# UNITED STATES PATENT AND TRADEMARK OFFICE

<b>Office Action Summary</b>	<b>Application No.</b> 10/663,107	<b>Applicant(s)</b> TSUCHIZAKI, AKIHIRO	
	<b>Examiner</b> Amy J. Sterling	<b>Art Unit</b> 3632

This is the first Office Action for application number 10/663,107 License Plate Holding Bracket and the Holding Structure thereof, filed on 9/16/03. Claims 1-21 are pending. This application claims priority to Japan 2002-270020, 2002-270040, 2002-270044, 2002-270109, 2002-270116 all dated 9/17/02.

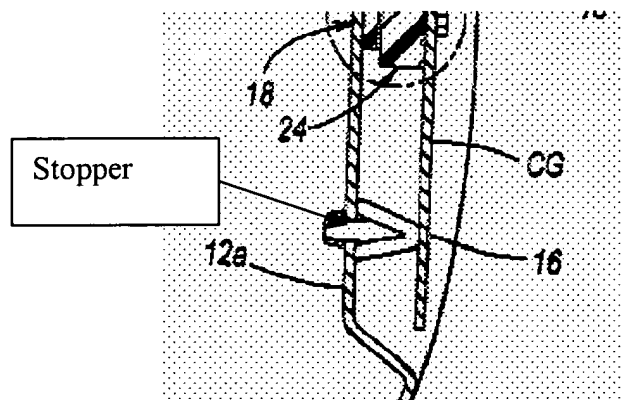
Smith discloses applicant's basic inventive concept including wherein the end side of the fixing member and the plate holding member are connected and both have a plane shape, and a stopper member (See Drawing Below, Fig. 6).

Smith does not teach wherein the stopper member resides on the plate holding member and is brought into contact with the rear bumper of a vehicle when the tailgate is horizontal and the license plate is almost erect with respect to the tailgate and contacts the tailgate and the gate side fixing member when the license plate is parallel to the tailgate and wherein the tailgate has a cavity for receiving the stopper.
